City of West Linn
PRE-APPLICATION CONFERENCE MEETING
Notes
June 21, 2012

SUBJECT: Class I Design Review to fill an existing wading pool and install pergola, install a trash compactor, install fencing around compactor and perimeter of Sunset Primary School at 2351 Oxford Street

Proposed encloserer will replace the existing facility, shown here.

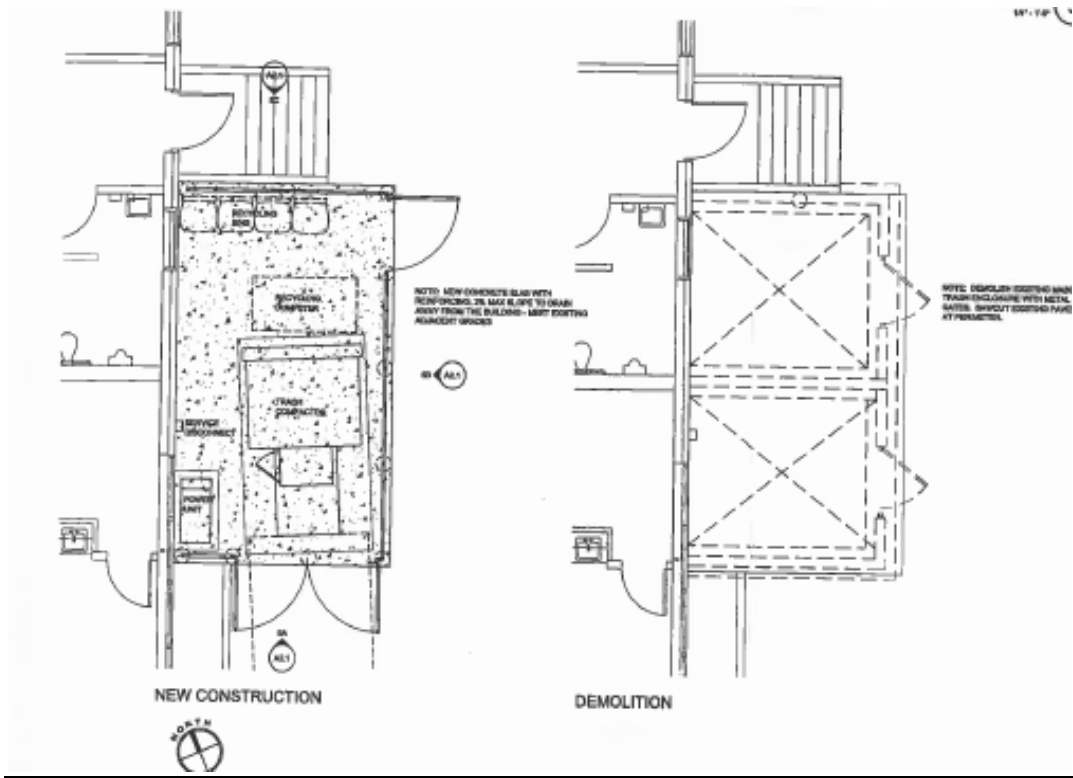
The existing trash facility is surrounded by a brick wall. The proposed facility will include a trash compactor and occupy a footprint only slightly larger than the current one. In other circumstances, this could be considered a “replacement in kind” and exempt from land use permits per section 55.025(D). However the fact that a noise producing compactor equipment will replace the traditional trash containers elevates it to Class I design review per section 55.020(Q) since it represents a potential increase in noise impacts on abutting properties.

At the pre-application conference, staff noted provisions in CDC Chapter 55.100(O) relating to garbage and recycling enclosures which were subsequently found to apply only to commercial, industrial and multi-family projects. They do not apply to public facilities like schools. That discovery eliminates the need to provide landscaping around the walled enclosure. It also eliminates the need, under section 55.100(O), to provide a masonry wall. The applicant initially proposed a chain link fence with slats to screen the garbage and compacter. Staff would hold firm on the use of masonry due to the superior noise deadening quality of masonry blocks over chain link fencing. A masonry wall is also preferred due to its ability to meet the architectural compatibility standards of 55.100(B) (6) (b) which calls for matching the existing building materials of the brick clad school.

Wading pool with proposed design below

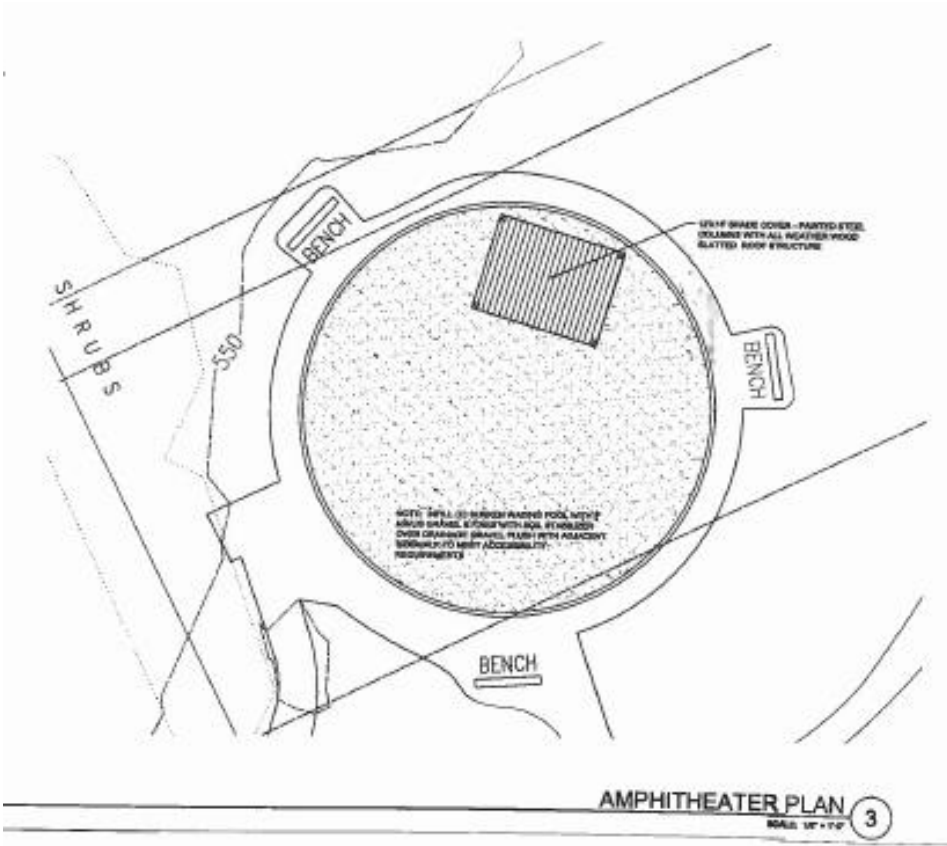
The wading pool/pergola triggers a Class I Design Review per section 55.020(L): *“Modification of a landscape plan (including water features, ponds, pergolas, arbors, artwork, sculptures, etc.)”*. The posts along the south property line also trigger Class I Design Review under either the same category as pergolas or the *“freestanding art or statuary over five feet tall”* category of 55.030(P)
